Memo

Re: **Consultation on an Application**

Planning Application Ref: PL/26/0923

Proposal: The extension and refurbishment of an existing derelict house. New off street parking and external landscaping

Rear Garden Plan – unclear planting

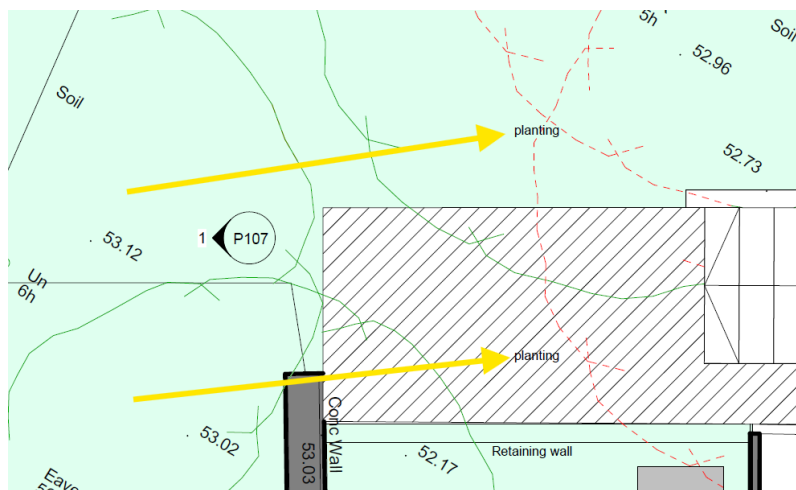
I firstly note that the AIA has not been revised since the previous application. The Rear Garden Plan shows a new patio and tree removals, yet these trees have not been surveyed within the AIA, which they need to be so that any impact to the trees in the rear garden can be assessed, along with appropriate mitigation. The patio may fall within an RPA, but we have no plan that plots the RPAs of the retained trees in the rear garden.

Whilst the new tree planting shown is positive, the total number of tree removals is not clear, so I cannot comment further as to whether this is acceptable mitigation. Both new trees in the rear garden are proposed to be the same species; for diversity purposes, a variety of species should be used.

The Rear Garden Plan is also not entirely correct. Planting is shown on hard surfaces and in green areas, so it is difficult to assess what is truly proposed:

Section Plan Through New Drive – excavation required

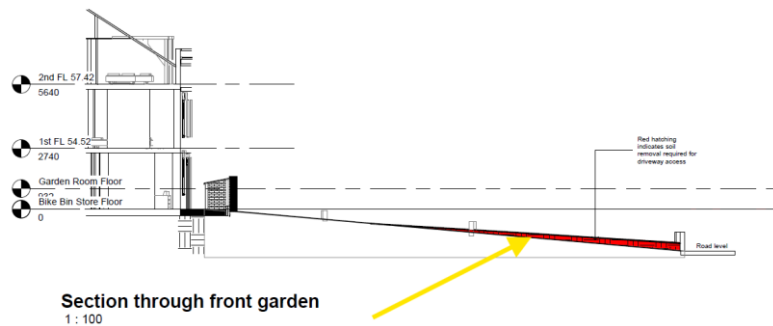
The Section Plan of the new driveway is a concern as it shows soil removal within the RPA of the protected Birch tree. We do not consider this acceptable as the BS5837, section 7.4.2.1 states that '*The design should not require excavation into the soil, including through lowering of levels and/or scraping, other than the removal, using hand tools, of any turf layer or other surface vegetation*'. Therefore, we do not consider this acceptable. The AIA also does not detail any excavation to install the driveway which I discuss further below, and instead uses a cellular confinement system, so it is a concern what is truly proposed to install the driveway. The Section Plan also doesn't label the cellular confinement system and how the ground levels would marry with the cellular confinement system.

There are several references to this being a ‘no dig’ method for installing the driveway in the AIA, but excavation is clearly required within the Section Plan. The AIA also states in Section 6.0 ‘*The ground levels on the side of the proposed driveway close to the stem of Tree 1 fall away sharply; therefore, excavations for the proposed driveway will not be required*’, so the extent and need for excavation, is particularly unclear. I assume the AIA has not been revised since my latest comments for the previous application, but it will need to address my previous and current concerns with the latest plans. As stated in my previous comments:

Proposed Site Plan – new access & front garden

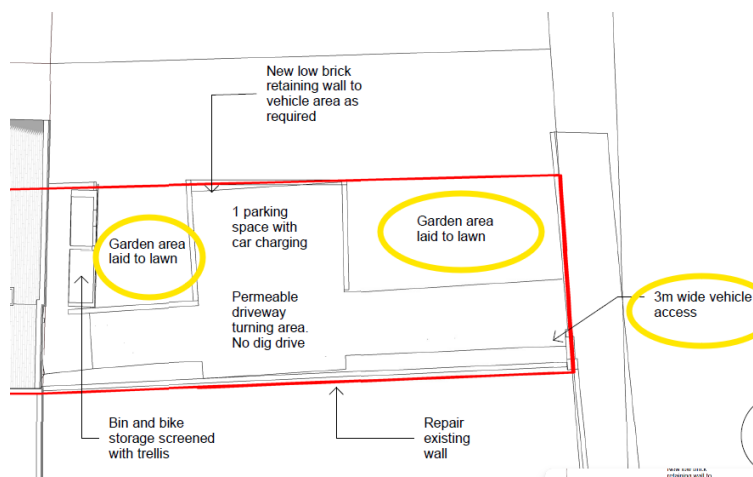
With reference to the Proposed Site Plan, Drawing No. P100, Rev P1, Issued: 8th July 2026, I note that the driveway access is proposed to be widened to 3m. Is this feasible with T1 Silver Birch adjacent to said access? With planning permission overriding TPO legislation, it must be ensured that this is feasible and doesn't lead to the tree ultimately being felled if planning permission cannot be implemented with its retention. I also question whether there is sufficient space for the tree to continue growing, being early-mature, it is expected to continue growing. The Proposed Site Plan doesn't plot the tree, so it is difficult to envisage whether this is feasible. It also makes several reference to the garden being laid to a lawn but doesn't show any planting including trees.

The Front Garden Plan still makes reference to replacement trees for the protected Silver Birch, stating 'New Himalayan birch to Tree consultant specification to replace silver birch'. The Silver Birch is being retained, so referencing replacements for it is concerning and should be omitted. Three new trees are also shown, yet only one is labelled.
